Subject: Draft Hydrology Safety Audit Trip Report Deliverable for JCN Q-4007, Task 35, Subtask 1b, "PNNL's Review of Levy County Combined Operating License Application in the Areas Relating to the Hydrologic Safety Analysis in SAR Sections 2.4.1 – 2.4.5 and 2.4.7 – 2.4.17" (TAC No. RX0338)

Levy County Nuclear Plant
Hydrology Safety Audit – November 03-07, 2008 – Trip Report

Figure 11. Computed tsunami height at Deshaies (Guadeloupe) and St. George's (Grenada) versus the distance to the source

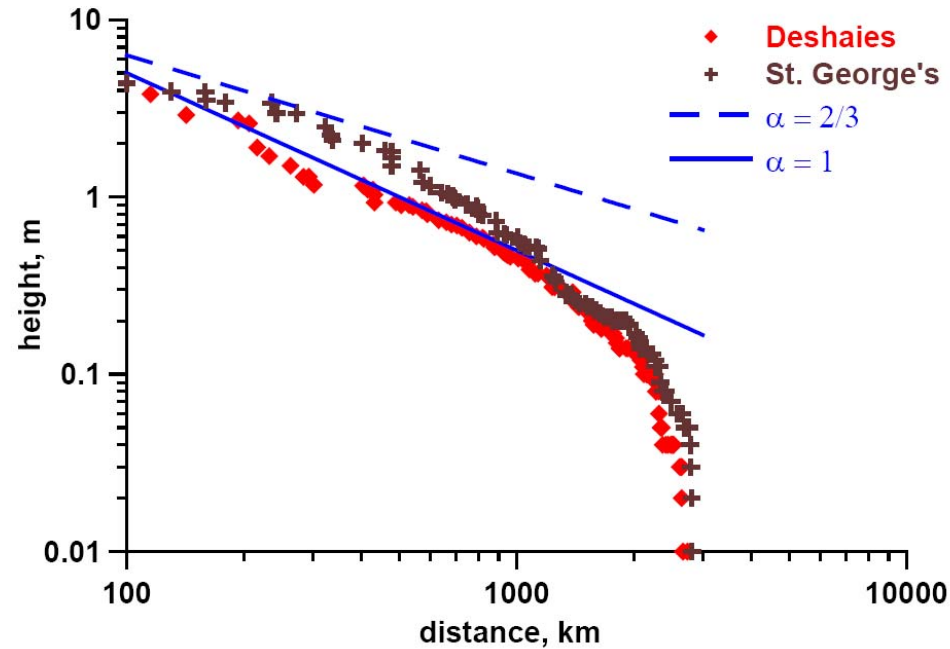
28.	2.4.6.4	<p>Provide an SME to discuss the theoretical basis, assumptions (e.g., source parameterization), and applicability to the Levy County site for the tsunami attenuation function discussed on pg. 2.4-53 (Equation 2.4.6-1). Also make available the details of the Monte Carlo analysis used to estimate the maximum wave height and where the maximum wave height estimate is geographically located.</p> <p>Applicant Response: LNP FSAR Equation 2.4.6-1 describes wave attenuation in the Caribbean as provided by Zaibo (2003) in “Estimation of Far-Field Tsunami Potential for the Caribbean coast Based on Numerical Simulation” (LNP FSAR Reference 2.4.6-222). As discussed in LNP FSAR Subsection 2.4.6.4.1.2:</p> <p><i>Zaibo’s (2003) (Reference 2.4-222) wave attenuation formula was used to determine the most likely maximum wave height that would be expected at the Levy County coastline as a result of this event. The formula is as follows:</i></p> $\frac{H(r)}{H_e} = 2 \left(\frac{r}{D} \right)^{-\alpha} \quad (\text{Equation 5; Reference 2.4-222})$ <p><i>where H_e is the hydrodynamic source height, D is the source diameter, r is the distance from the source to the location of interest, and α is the attenuation ratio (Reference 2.4-222).</i></p> <p>Zaibo (2003) validated this equation by comparing calculated results to observed wave heights produced by the 1867 Virgin tsunami at 3467 gridded points distributed across four zones in the Caribbean, including the great Antilles, Jamaica, the Lesser Antilles, and the Caribbean coasts of Central and South America. It has been inferred that the equation is equally applicable to the Gulf Coast region due to proximity.</p> <p>While it was determined that the function produces accurate results for source distances up to 1,000 km, results for distances greater than 1,000 km tend to be more conservative than observed values as seen in Figure 11 (below), page 219 of the paper (Zaibo 2003). In other words, calculated wave heights at points more than 1,000 km from the tsunami source are consistently greater than the observed wave heights. Because the LNP site is more than 1,000 km away from the tsunami source evaluated using this equation, it is clear that the attenuation results derived from this equation are</p>	P. Lynett

According to the wave attenuation equation, wave height is dependent on several factors, including bottom irregularities, distance from source, wave height at source, and the diameter of the source. Attenuation is captured in one parameter, α , which produces minimum attenuation when equal to 0.67 and maximum attenuation when equal to -1. The parameterization of each of these variables is described in the FSAR as follows:

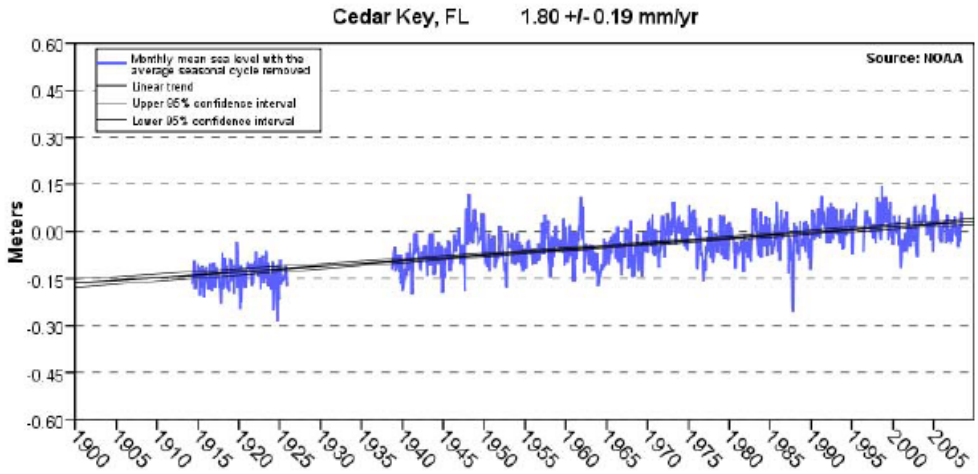
Provide an SME to clarify the source of the PMT for the Levy County site. Is it the East Breaks landslide with an estimated 1.68 m maximum wave height (pg. 2.4-53), the Venezuela earthquake with an estimated 1.95 m maximum runup height (pg. 2.4-58)?

The source of the PMT event for the Levy County plant site is a near field landslide event. However, the occurrence of such an event is highly unlikely, as landslide events have not been a source of any tsunami that has been documented instrumentally or in the geologic record for the Gulf Coast. As such, a discussion of potential PMT events related to seismic activity as suggested by NOAA and USGS was also provided in the LNP FSAR.

In addition to being unlikely, the tsunamigenic threat of near-field and far-field landslides within the Gulf of Mexico is difficult to characterize due to lack of information. However, for the purpose of this report, a conservative analysis of the East Breaks landslide as a tsunamigenic source was conducted to determine the potential worst case impacts from a landslide-generated tsunami. Analysis indicates that such an event could produce a tsunami with an offshore wave height of 1.68 m. As suggested by the
